主旨: Fwd: A/NE-TKL/817

Detailed Comments from Relevant Government Departments

Comments of the Chief Engineer/Mainland North, Drainage Services Department (CE/MN, DSD):

卓 弘 測 量 服 務 公 司	Project Title Lot No. 1495 S.B ss.2 RP IN D.D. 76,	Scale	Figure No.
CHUO WANG SURVEY SERVICES COMPANY	Hung Leng, Fanling, N.T.		STDP-01
	Figure Title Proposed Stormwater Drainage Plan	Date 22-07-2025	Revision

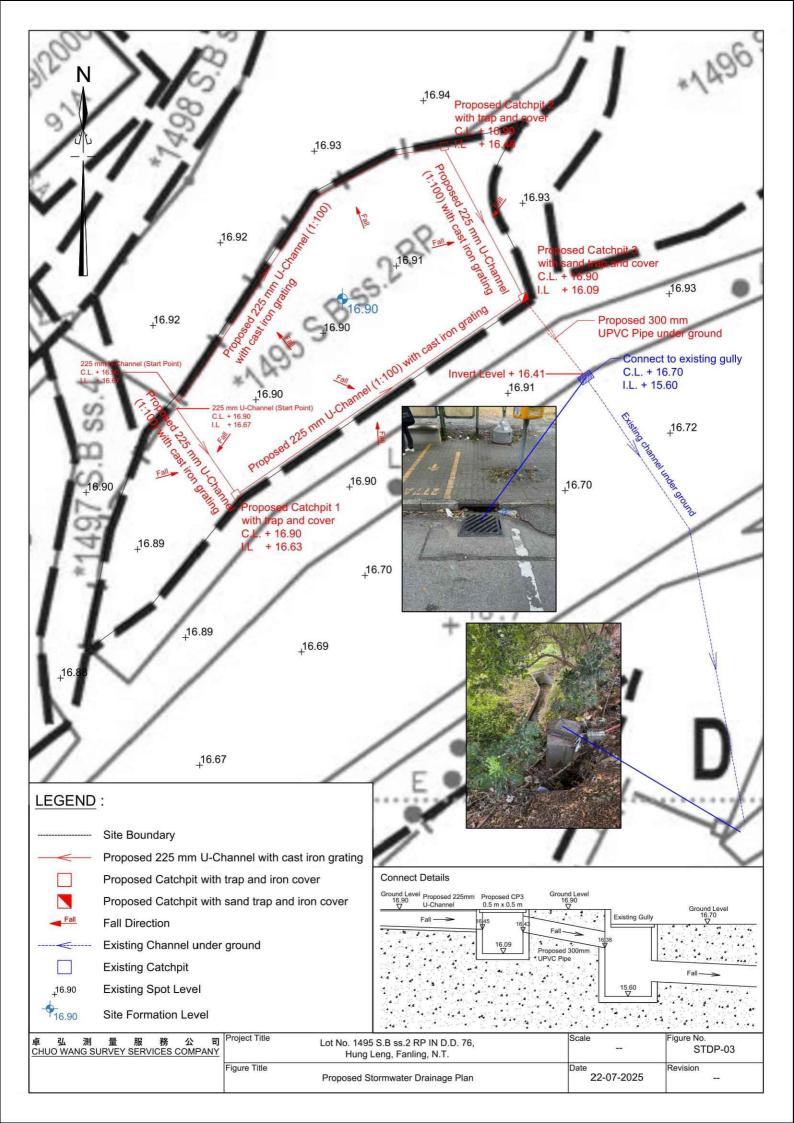
- Regarding figure No. STDP-03, the applicants should review and update the following:
 - (i) the upstream invert level of the proposed 300mm underground pipe is lower than its downstream invert level;

- (ii) the "Connect Details" does not match the plan;
 - (iii) the cover and invert levels of the starting points of u-channels are not legible; and
 - (iv) the minimum cover from the surface of the footway to the top of the pipeline shall be 450 mm;
